ANSTY GARDEN COMMUNITY,

DESIGNERS RESPONSE

REPORT REF NO. 2207280-R19B

- 1.6 The following drawing have been prepared to incorporate the findings of the RSA:
 - **ACE Drawing 2207280-007D** – Proposed Cycle Connections A272 / Bolney Road / B2036

Drawing Title: **PROPOSED CYCLE CONNECTIONS A272 / BOLNEY ROAD / B2036**

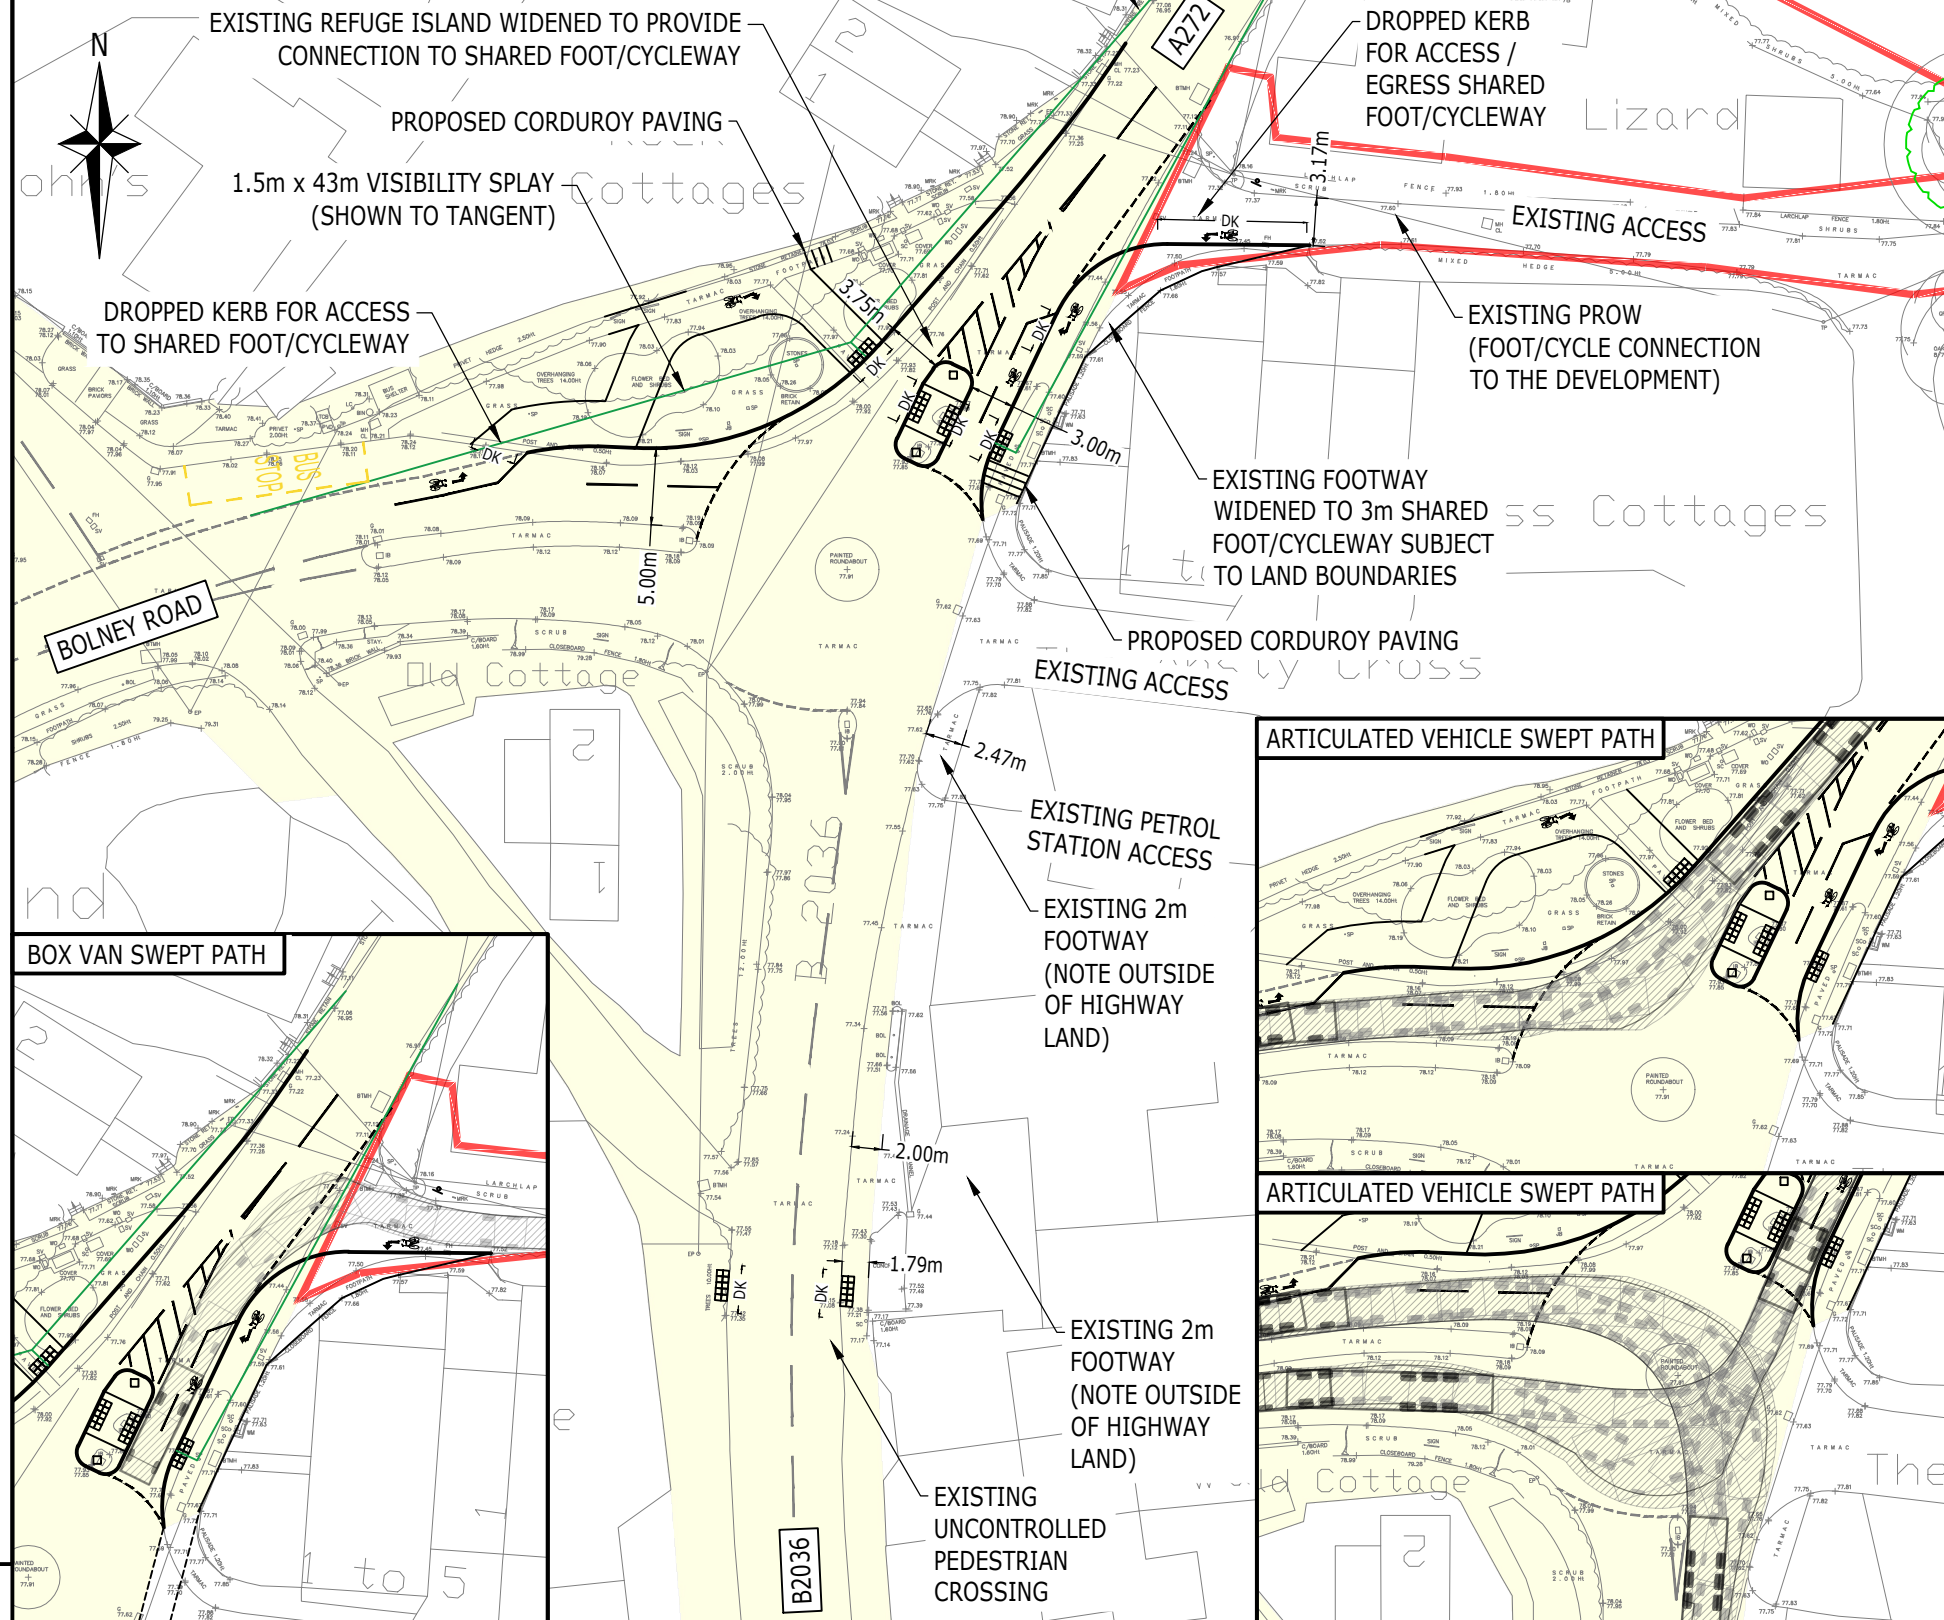
Summary: Vehicles entering the opposing carriageway at bend may lead to collisions with parked vehicles, side swipe collisions or vehicle to pedestrian collisions.

Kerblines are being amended to accommodate the proposed scheme; however, no swept paths have been provided assessment. There is concern that larger vehicles such a refuse vehicle may

not be able to undertake turning manoeuvres without entering the adjacent running lane or opposing carriageway or colliding with street furniture. Insufficient carriageway space could lead to sideswipe collisions, or footway overrun and potential vehicle to pedestrian collisions, or collisions with the pedestrian refuge, and possible loss of control collisions.

<p>to sideswipe collisions, or footway overrun and potential vehicle to pedestrian collisions, or collisions with the pedestrian refuge, and possible loss of control collisions.</p>				
<p>3.3.1 Insufficient capacity could lead to rear end shunt or side impact collisions.</p> <p>No details of expected flows and the capacity of the roundabout have been provided for assessment. Insufficient capacity could lead to congestion, where excessive queuing at the roundabout could lead to driver frustration and the use of inappropriate gaps, further unbalanced flows could lead to entry problems on to the roundabout. This may lead to rear end shunt or side impact collisions.</p>	<p>It is recommended that the roundabout should operate without excessive queuing and with balanced flows and that an ARCADY or similar model should be provided for assessment.</p>	<p>Agree. An ARCADY assessment has been undertaken and demonstrates that the junction operates with spare capacity in the Development Case scenario. The results are attached at Appendix C.</p>	<p>Junction Modelling has been provided and is acceptable</p>	<p>No further action at this stage.</p>

D	ADDITIONAL ARTICULATED VEHICLE TRACKS ADDED	BT	BT	DH	15.05.25
C	ARTICULATED VEHICLE TRACKS ADDED	DV	DV	DH	29.04.25
B	UPDATED FOLLOWING STAGE 1 RSA COMMENTS	DV	DV	DH	17.10.23
A	UPDATED TO ALLOW 5m ENTRY WIDTH	DV	DV	DH	22.09.23
Rev	Description	Drn	Chk	App	Date

Plan attached showing the locations of the problems identified as part of this audit (location numbers refer to paragraph numbers in the report).

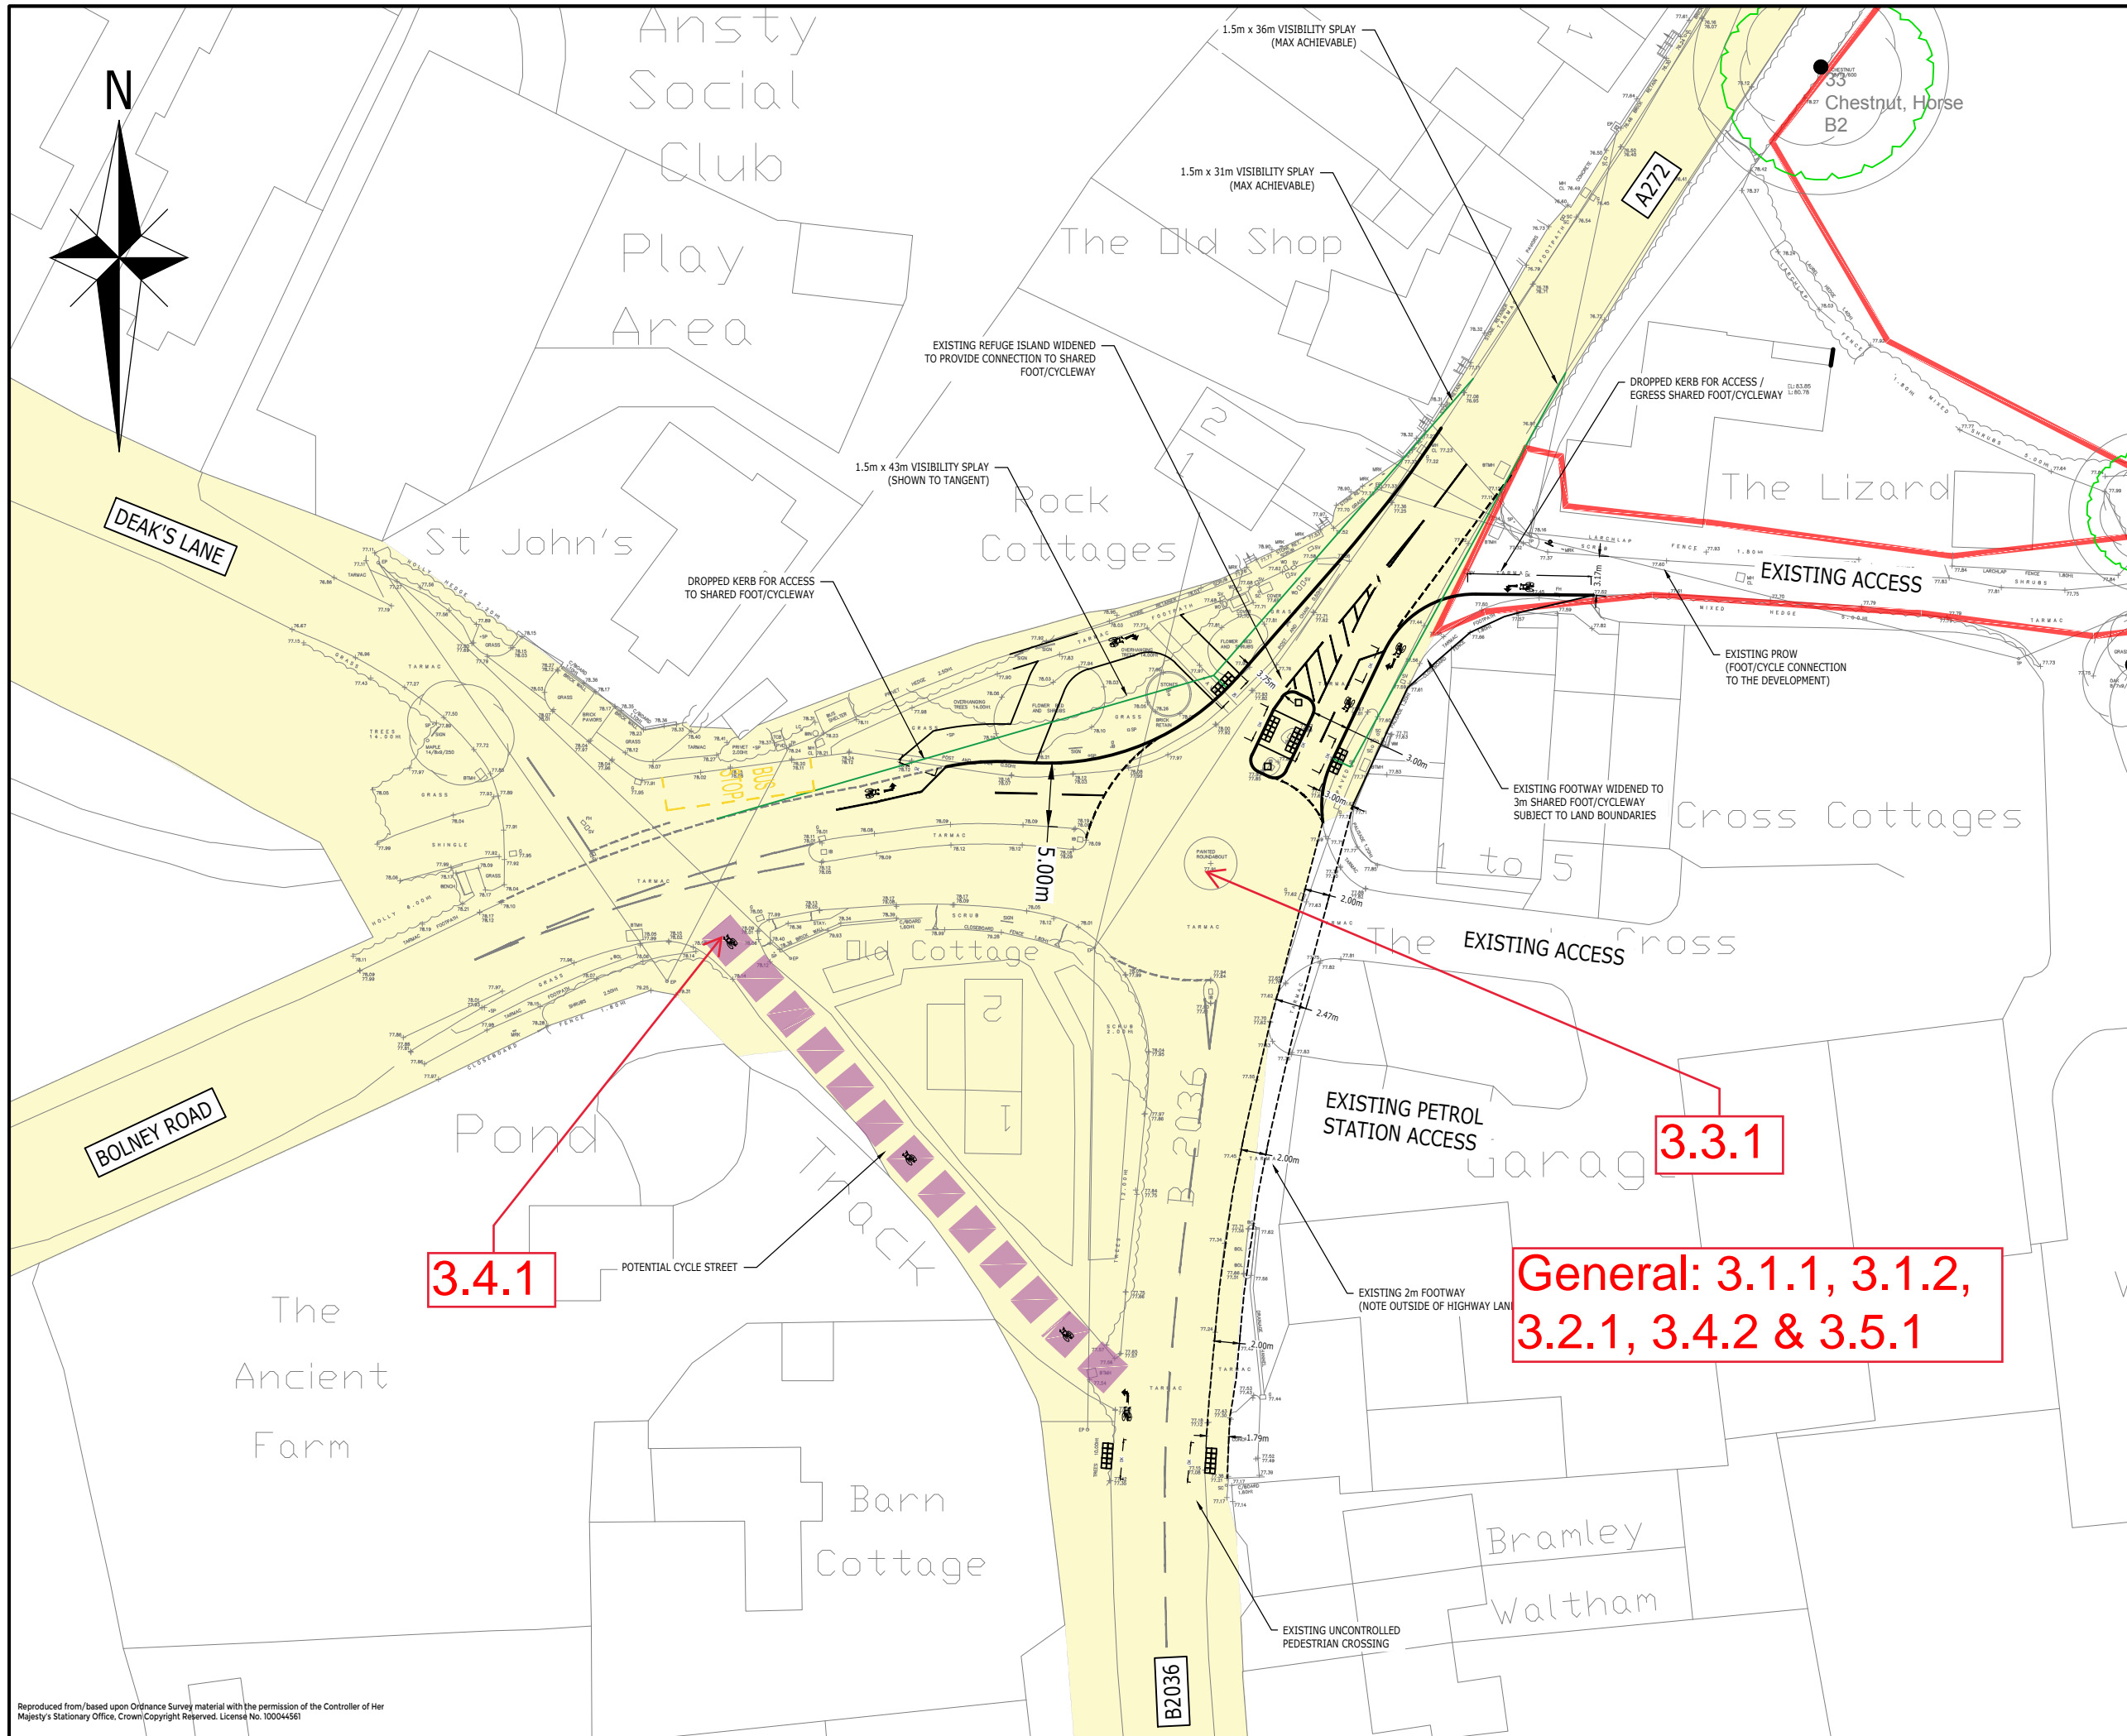
Summary: Insufficient construction details could lead to overshoot or rear end shunt collisions.

Summary: Ponding of surface water could lead to loss of control collisions.

Summary: Insufficient capacity could lead to rear end shunt or side impact collisions.

Summary: Restricted visibility could lead to vehicle to cyclist collisions.

Summary: Absence of tactile paving could lead to cyclist to pedestrian collisions.

Summary: Absence of vertical cyclist signage could lead to cyclist to pedestrian collisions.
